SI B51 35 18
Body Equipment

RATTLE FROM DOOR WHEN CLOSED WITH THE WINDOW LOWERED

I15 (I8 Roadster)

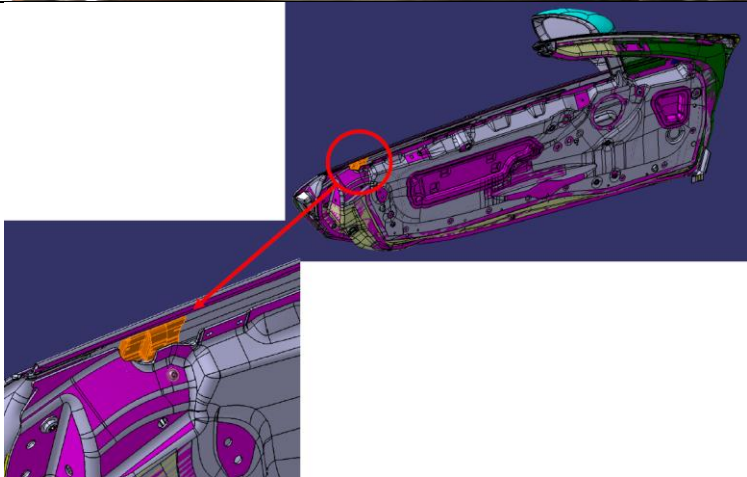
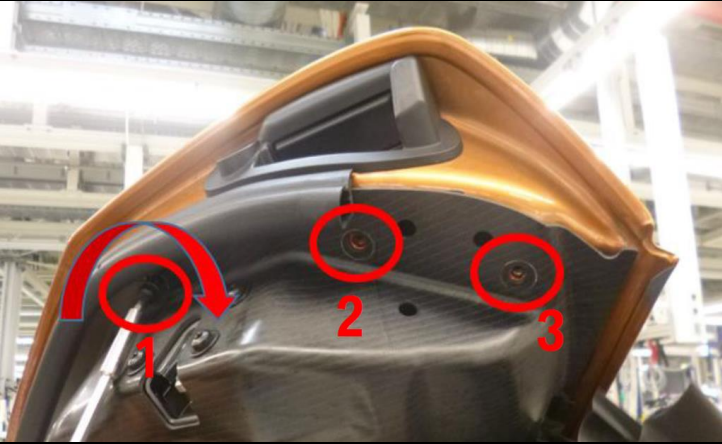
The window guide allows for excessive vibration with the window lowered.

Install an updated window guide on the affected door. Updated window guides can be identified by flocking material on the guide, whereas older style guides are made completely of rubber.

Install updated window guide(s) in the affected door. Refer to the attachment below:
